IVEY INTERSTATE INDUSTRIAL CENTER #1

Reference: Ivey Interstate Industrial Center#1 – Modification Request Letter

FILE NO. SUSU25-00026

SUBDIVISION NAME: Ivey Interstate Industrial Center #1

1. To waive the construction of one foot (1') of sidewalk along Gateway East Blvd.

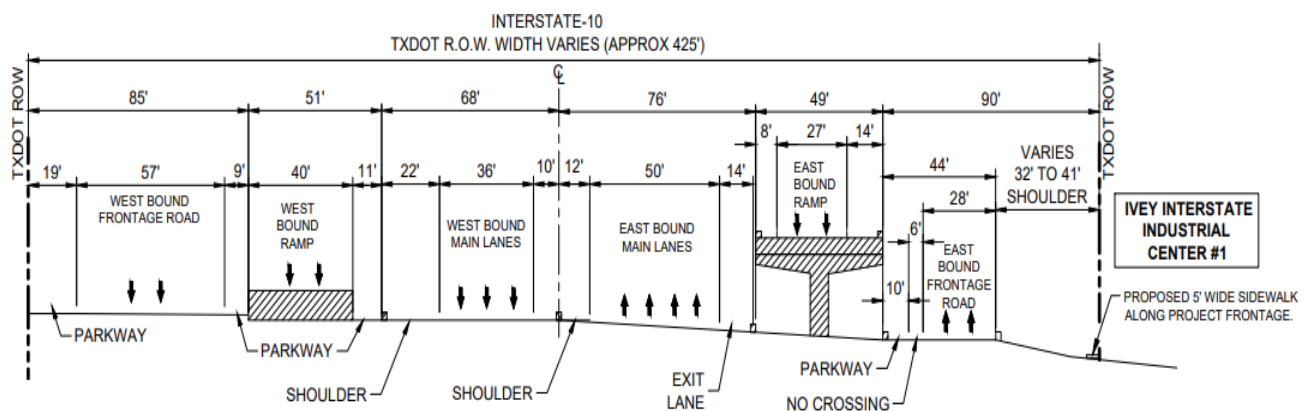
REQUIRED CROSS-SECTION:

PROPOSED CROSS-SECTION:

2. To waive the construction of one foot (1') of sidewalk along Americas Avenue.

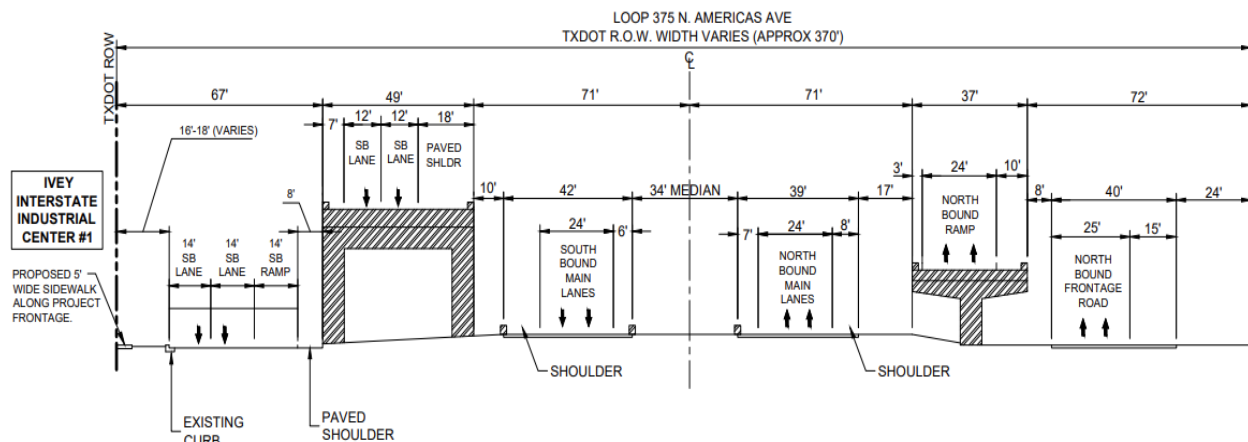
REQUIRED CROSS-SECTION:

PROPOSED CROSS-SECTION:

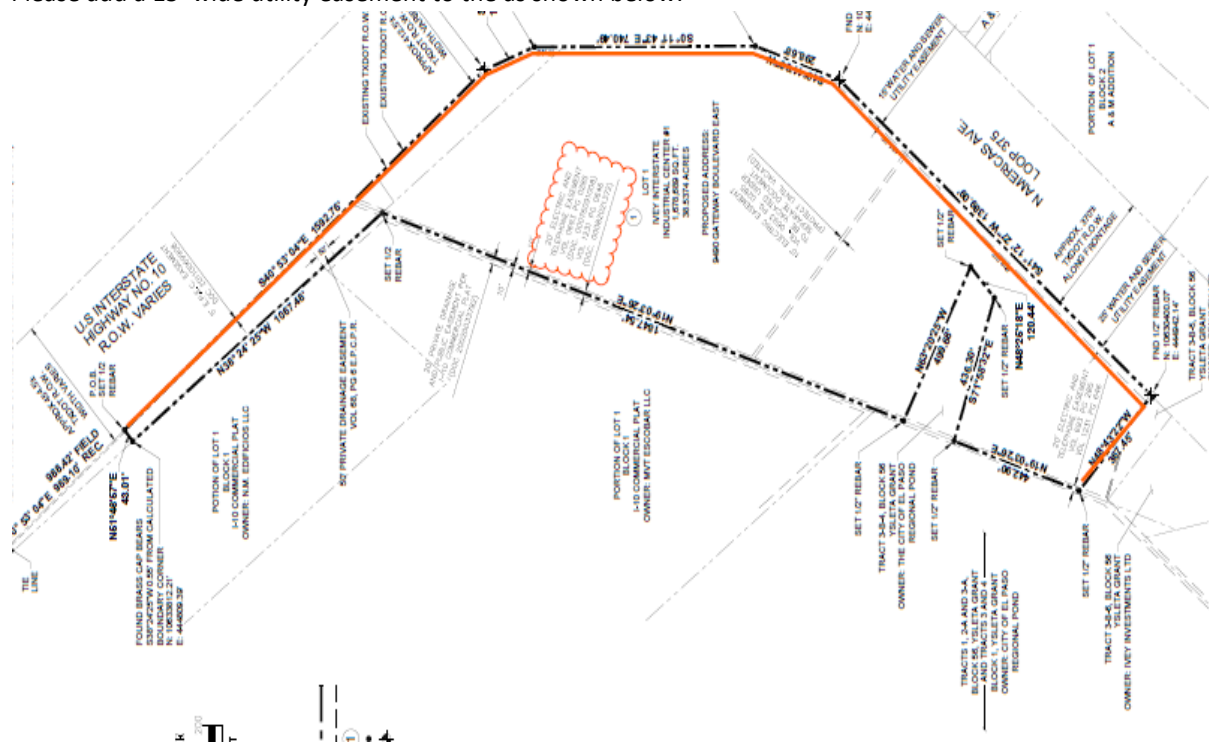
Please add a 15' wide utility easement to the as shown below:
